**ONONDAGA LAKE BOTTOM  
PHASE I – SEDIMENT CONSOLIDATION  
AREA CONSTRUCTION  
CONSTRUCTION QUALITY ASSURANCE (COA)  
FINAL REPORT – Volume I  
ONONDAGA COUNTY  
TOWN OF CAMILLUS, NEW YORK**

Project Number GJ4706B

May 2012 (Revision 0)  
August 2012 (Revision 3)

Notes:

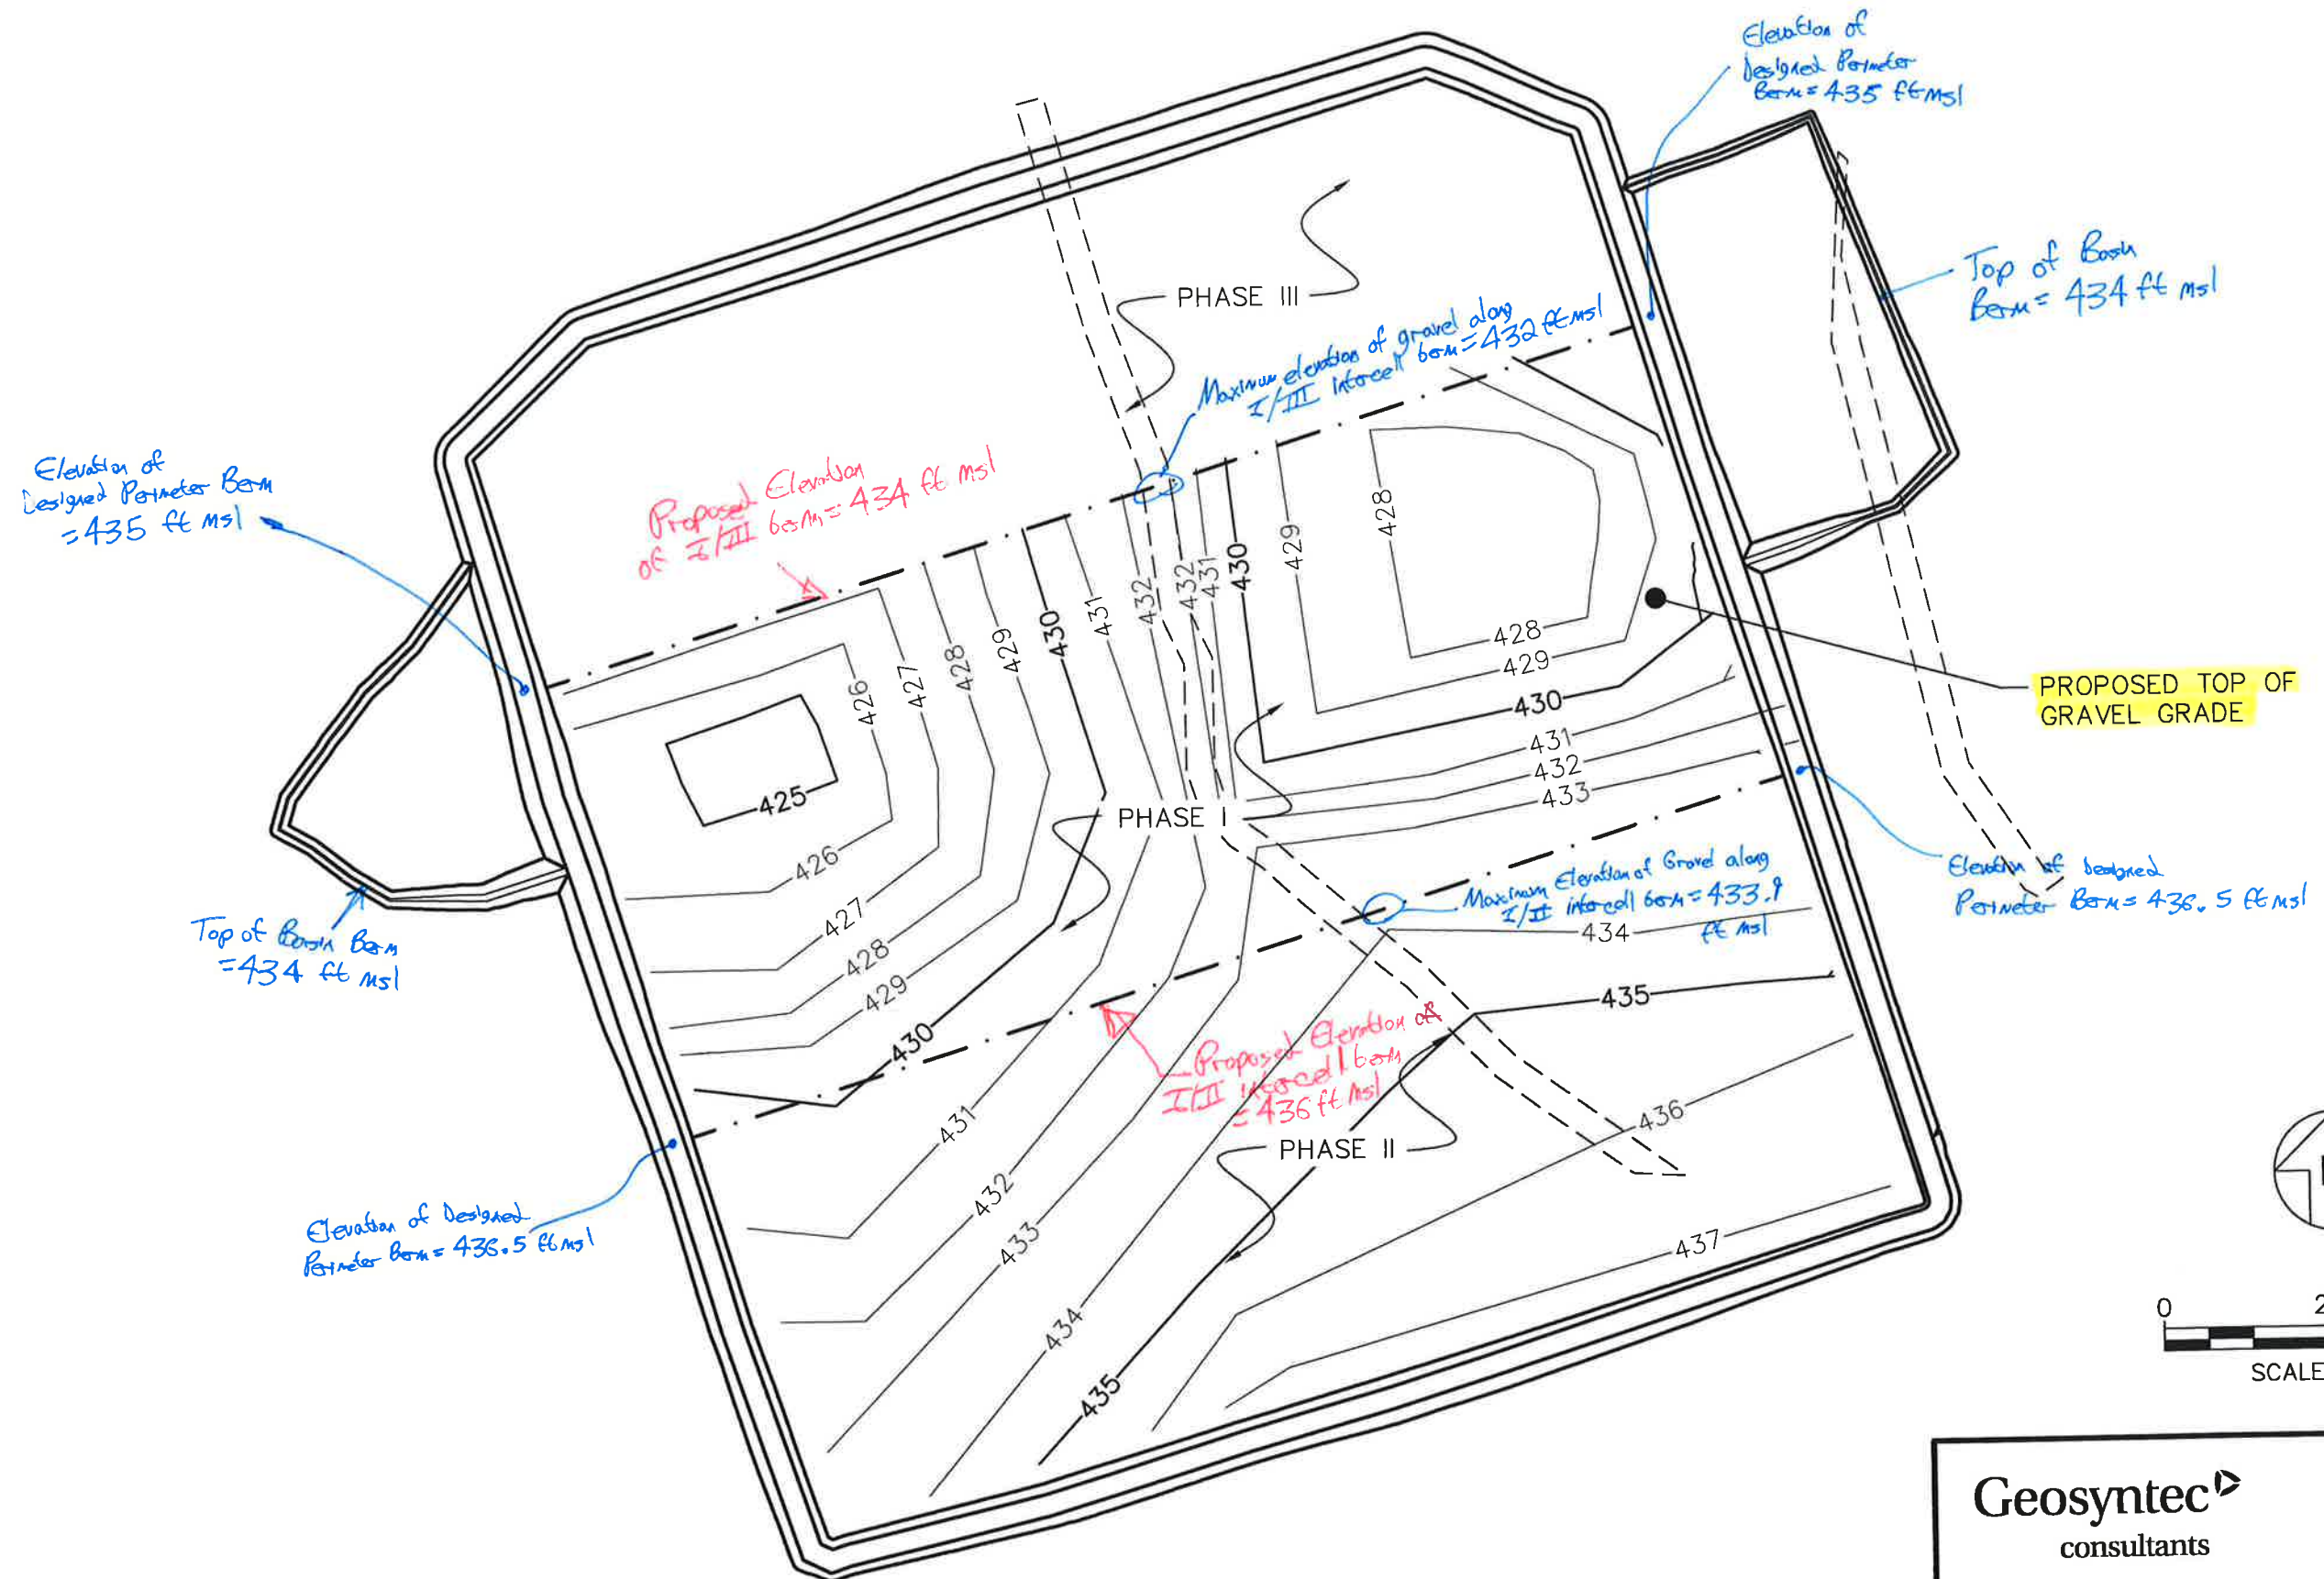
Drawing C-006 shows the elevations for the top of the berms around the SCA. Drawing C-009 shows the height of the temporary berm to be 5.7 feet. The east and west berms of the SCA are being built 0.5 feet lower than the design to account for the land-based topography data (as discussed in Field Change Form #3). This RFI is to ask what elevations are required for the top of the east and west berms and the top of the temporary berm to provide the necessary containment during the period when only Phase I and II are in operation.

Original Analysis - Before survey bust, minimum berm elevation of 434 ft msl

- 1.) It is noted that the minimum height of the berm is considered to be 2 ft above the Top of Gravel. This results in a minimum berm elevation of 434 ft msl in Phase I and 436 ft msl in Phase II.
- 2.) The minimum freeboard requirement is considered to be 0.5 ft (6").
